WILLIAMSON COUNTY, TEXAS

CHANGE ORDER NUMBER: 2

Project:	<u>1901-285</u>
Roadway:	<u>CR 176 at RM 2243</u>
CSJ Number:	<u></u>

CR 176 at RM 2243 Williamson County Project No. 1902-285 Change Order No. 2

CR 176
AT RM 2243
SHARED USE PATH
PLAN

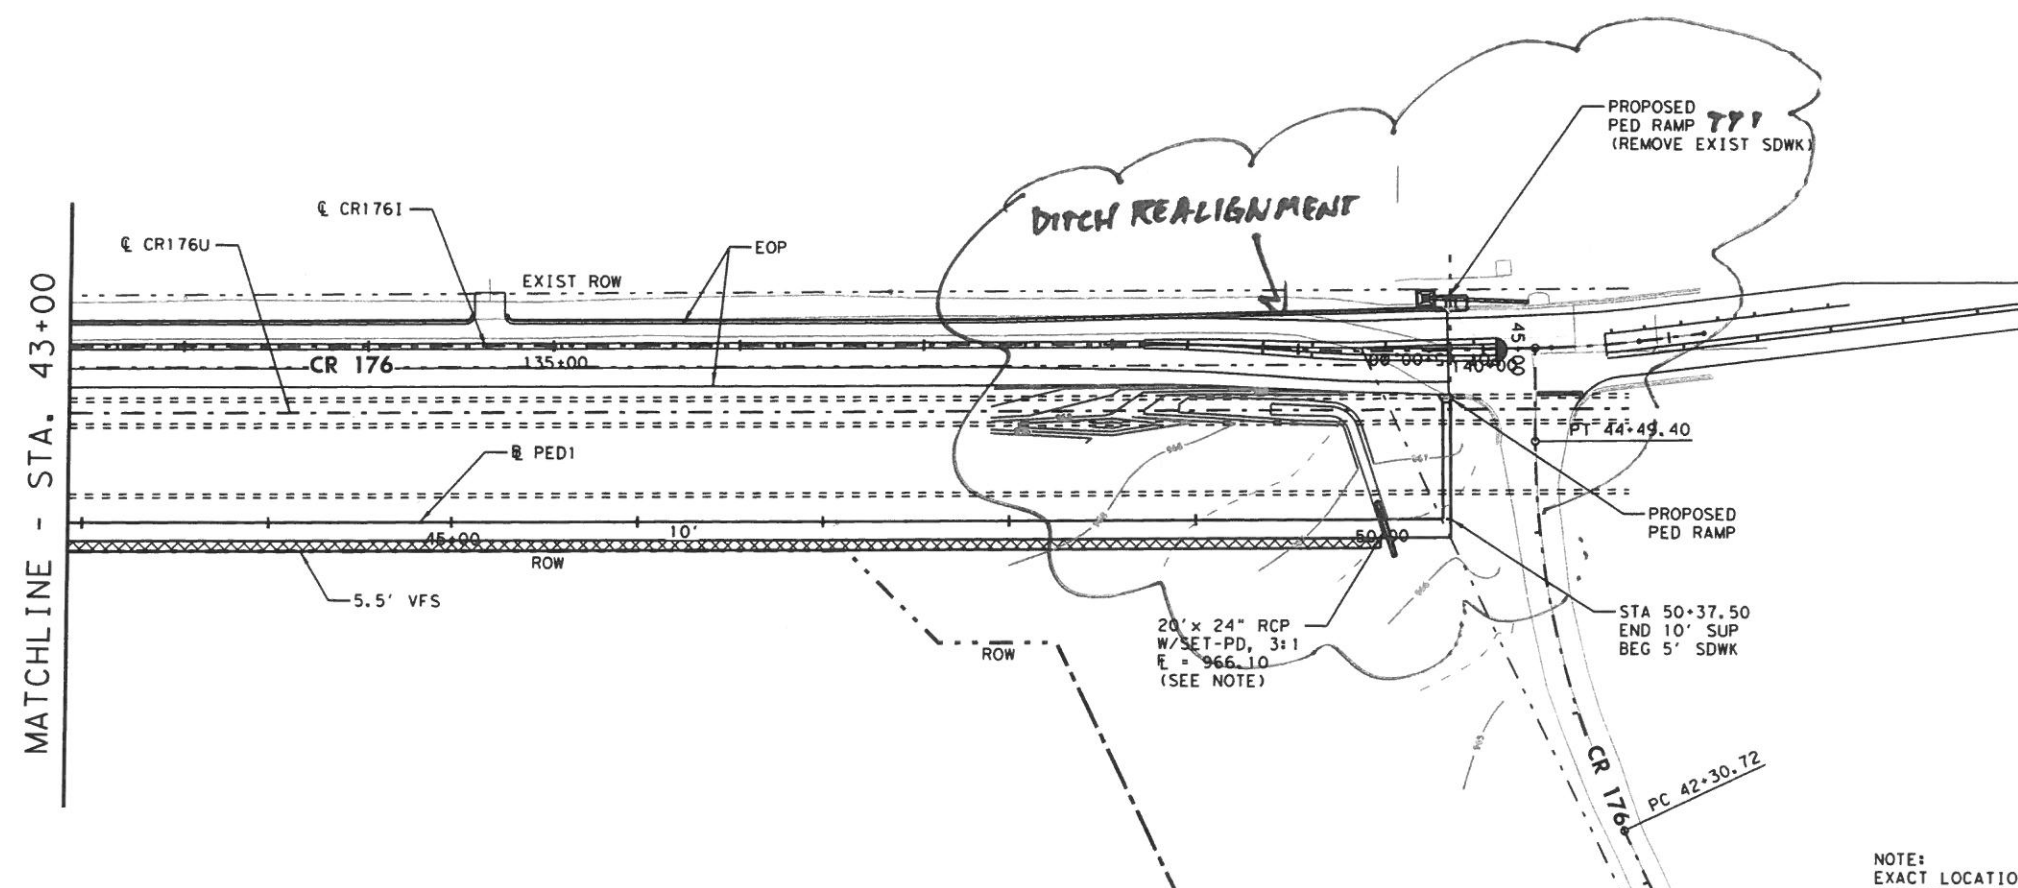
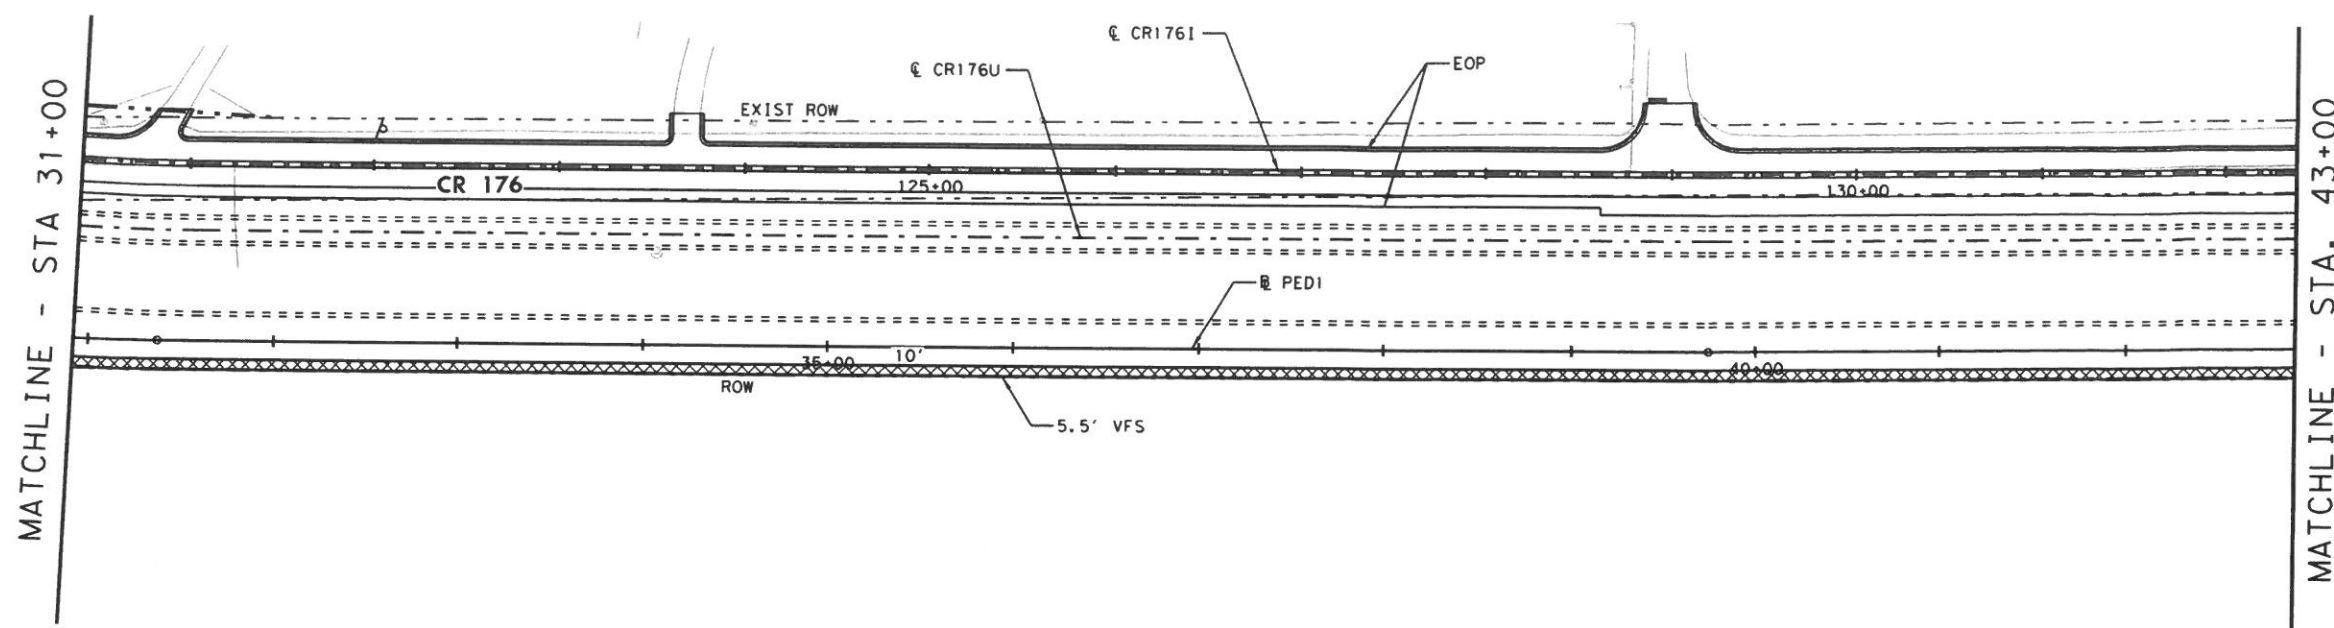
The Contractor cut the ditch on the south end of the project along the roadway according to the information shown on plan sheet 61A. During construction of the ditch it was determined that the ditch could not be constructed to drain within the right of way along (ROW) existing CR 176 near Station 42+00. Item 999-WC03 compensates the contractor for time and equipment necessary to realign the ditch to provide proper drainage within the ROW.

NOTE:
EXACT LOCATION OF 24" RCP TO BE DETERMINED
IN THE FIELD. CULVERT TO BE INSTALLED IN E
OF GRADED DITCH.
